TO: Mercedes-Benz Dealer Principals, General Managers, Sales Managers, Service Managers, Parts Managers	FROM: Gregory Gunther, Senior Manager, Vehicle Compliance and Analysis, Engineering Services
RE: Service Campaign Launch Notification Retrofit Headlamp Housing Screws MY22 SL (232 platform)	DATE: January 19, 2024

Retrofit Headlamp Housing Screws

Service Campaign Bulletin

SUBJECT: **Model SL (232 platform)**
Model Year 2022

Figure 2

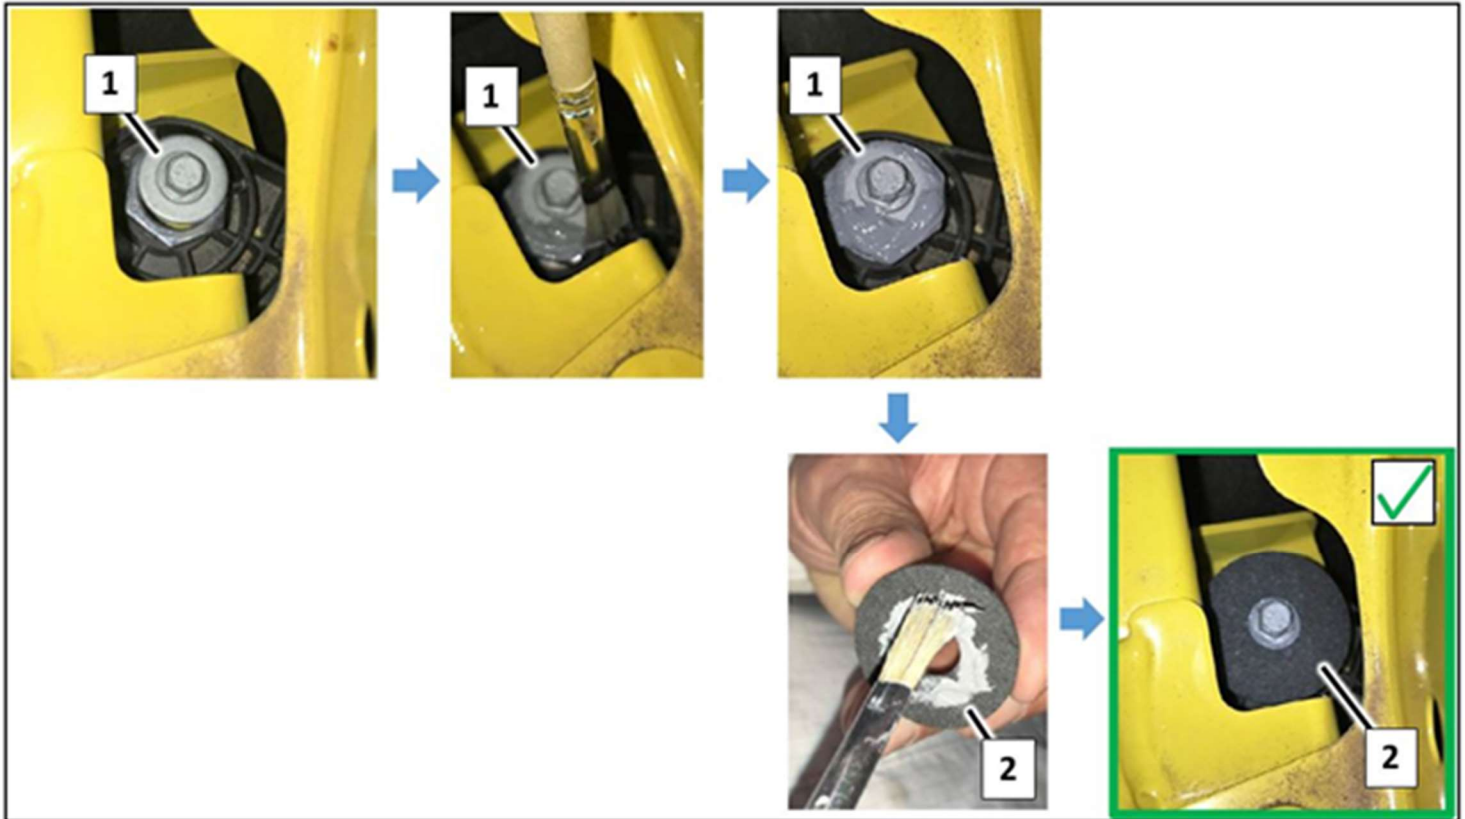
2. Coat washer (1, **Figure 2**) on left and right headlamp housing screws **and** felt (2, **Figure 2**) with windshield adhesive.

i The entire contact surface must be coated with windshield adhesive.

3. Glue felt (2, **Figure 2**) onto washer (1, **Figure 2**) of left and right headlamp housing screws so that it is flush.

4. Remove any excess adhesive with a lint-free cloth and suitable cleaning agent.

i Driving at a speed above 74 mph should be avoided in the first 24 hours.
